SUBJECT: ISSUANCE OF AMENDMENT NO. 4 TO LICENSE NO. DPR-75 - SALEM NUCLEAR GENERATING STATION, UNIT NO. 2

AMENDMENT TO FACILITY OPERATING LICENSE

Amendment No. 4
License No. DPR-75

SAFETY EVALUATION
BY THE OFFICE OF NUCLEAR REACTOR REGULATION
RELATED TO AMENDMENT NO. 4
TO FACILITY OPERATING LICENSE NO. DPR-75
PUBLIC SERVICE ELECTRIC AND GAS COMPANY
SALEM GENERATING STATION, UNIT NO. 2
DOCKET NO: 50-311

FIGURE 6.2.2 FACILITY ORGANIZATION-SALEM GENERATING STATION

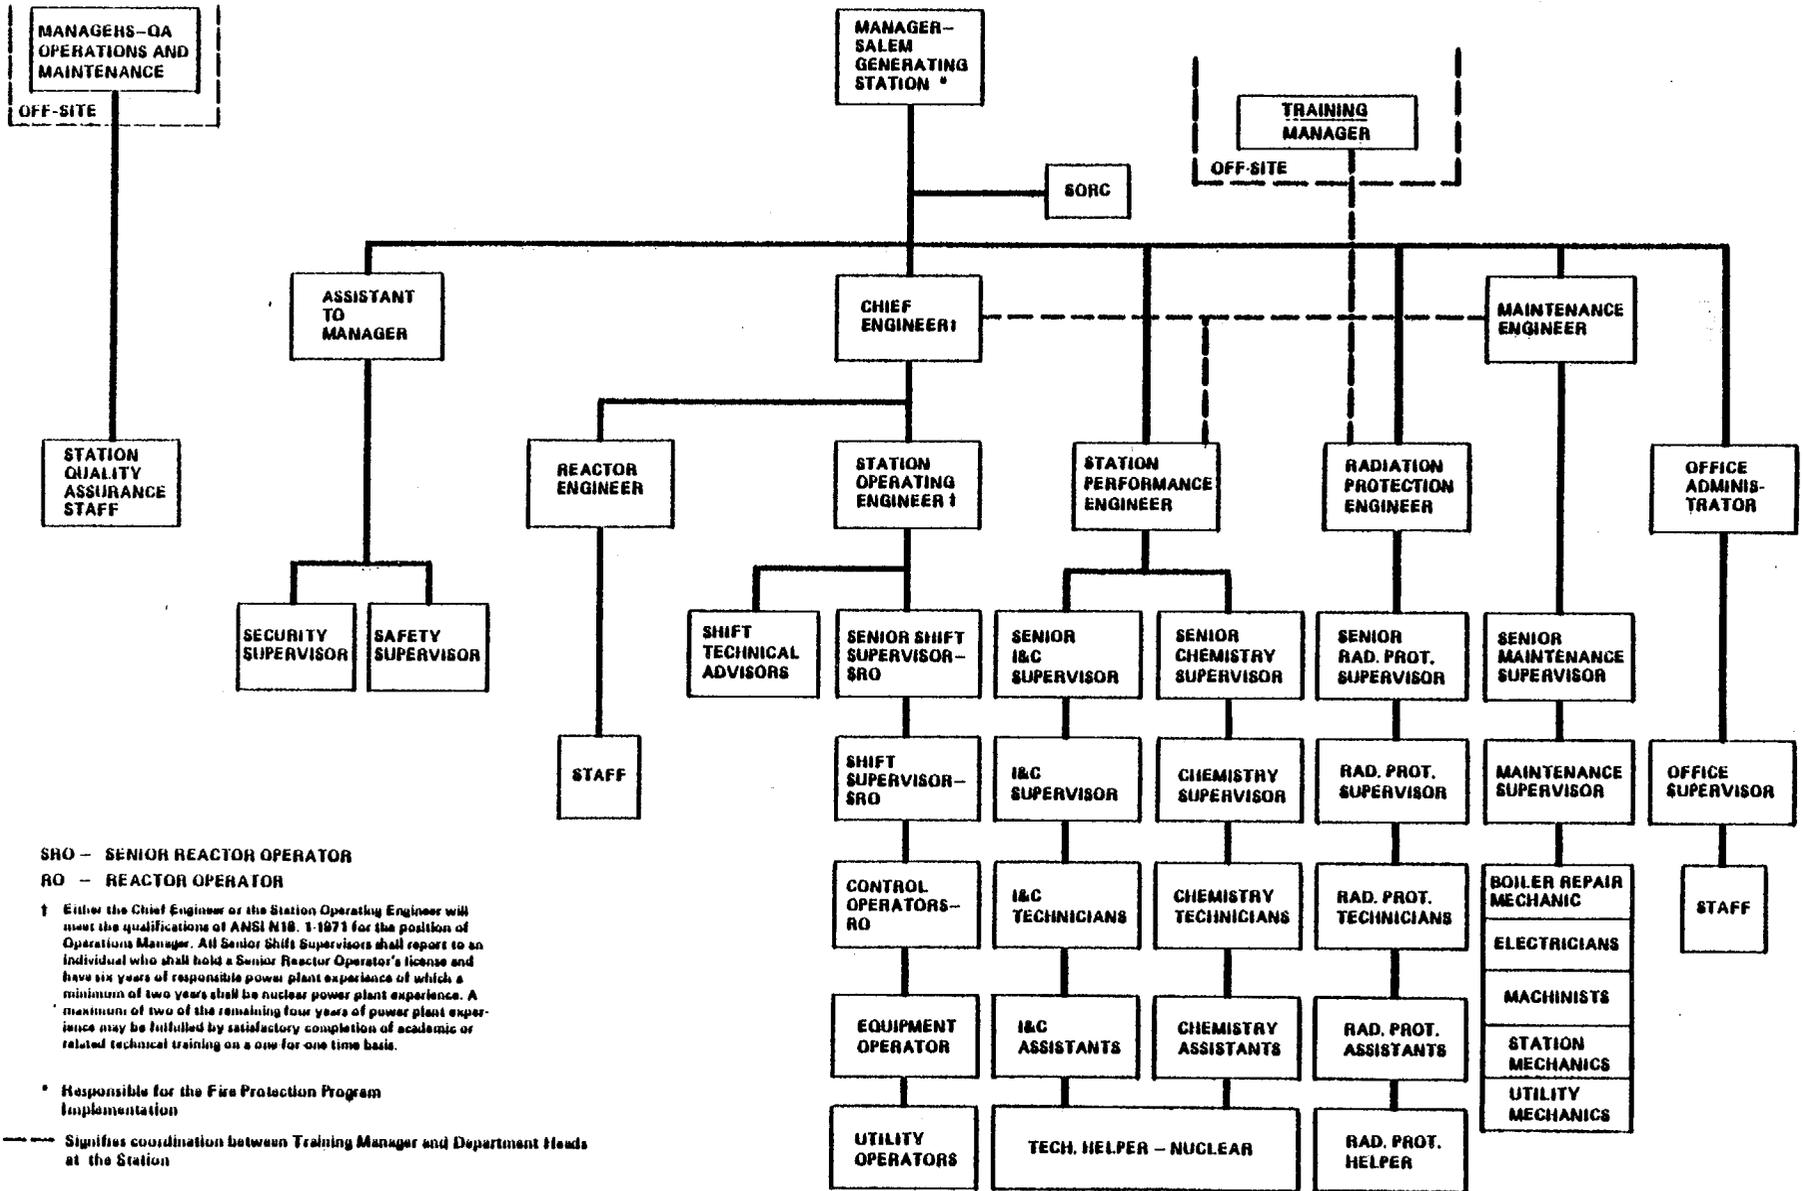
Figure 6.2-2, attached, depicts the proposed new station organization. There are a number of significant changes that the licensee proposes to make. In addition to a number of title changes, the Radiation Protection Engineer has now been moved such that he is free from plant operational pressures and has direct access to the Station Manager. This is in accord with the desires of the NRR Radiation Assessment Branch and is acceptable. The Senior Training Supervisor at the Station has been replaced by a corporate level Training Manager, who coordinates training activities directly with the Department Heads at the Station. This should result in increased emphasis on training and is acceptable.

At the time the license for Unit 2 was issued, the licensee had the Shift Technical Advisors reporting to the Reactor Engineer. By letter dated October 29, 1980, the licensee informed us that, in order to obtain a greater involvement of the STAs in shift operation and an improved awareness of plant conditions, the STAs had been shifted so that they would report to the Operating Engineer rather than the Reactor Engineer. This change is reflected on the attached Figure 6.2-2. This reporting arrangement maintains STA independence from the actual shift operating crew and is acceptable.

Figure 6.2-2 also shows the Station Quality Assurance Staff now reporting to the Manager - QA Operations and Maintenance at the Corporate level who, in turn, reports to the new General Manager - Corporate Quality Assurance, as shown on Figure 6.2-1. This maintains the independence of Station QA activities from operating pressures and is acceptable.
